Vermont Agency of Transportation
RECEIVED
CK'D BY RSF/SMC OK'D BY WDL
May 19, 2016
RESUBMIT No Approved AsNoted
BY RSY DATE 05/26/2016

DESCRIPTION: STANDARD DETAILS

STRUCTURE:	TH-4 OVER WHITNEY BROOK ROUTE NO: TH-4, RURAL MINOR COLLECTOR BRIDGE REPLACEMENT COUNTY OF ORLEANS	DRAWN: JTB	DATE: 02/25
		CHKD: LWD	DATE: 03/02
LOCATION:	TOWN OF CRAFTSBURY, VERMONT	JOB NO.	DWG NO.
PROJ NO.	BO 1449(34)	649-1	X1
CUSTOMER:	CCS CONSTRUCTORS INC.		REV. 1

15 ~ x1n
INT. DIAPHRAGM

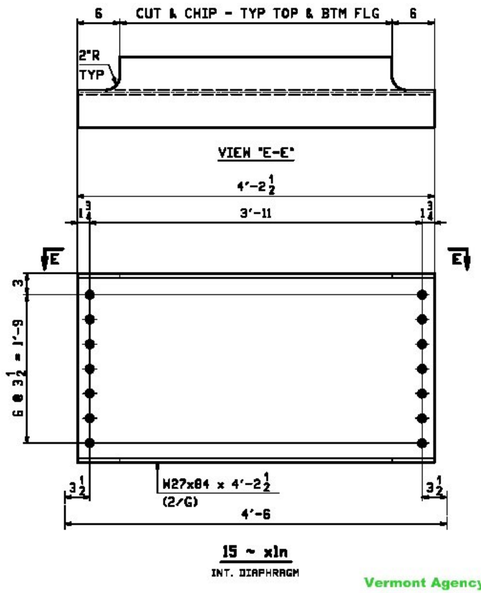
IS THIS APPROVED TO MAKE THESE NON-WEATHERING STEEL??

Discussed with PM and we don't see an issue - encased in deck concrete and shear studs are non-weathering.

24 ~ x1a
ABUT BRG STIFFENER

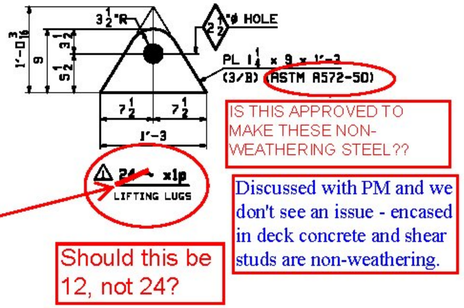
Should this be 12, not 24?
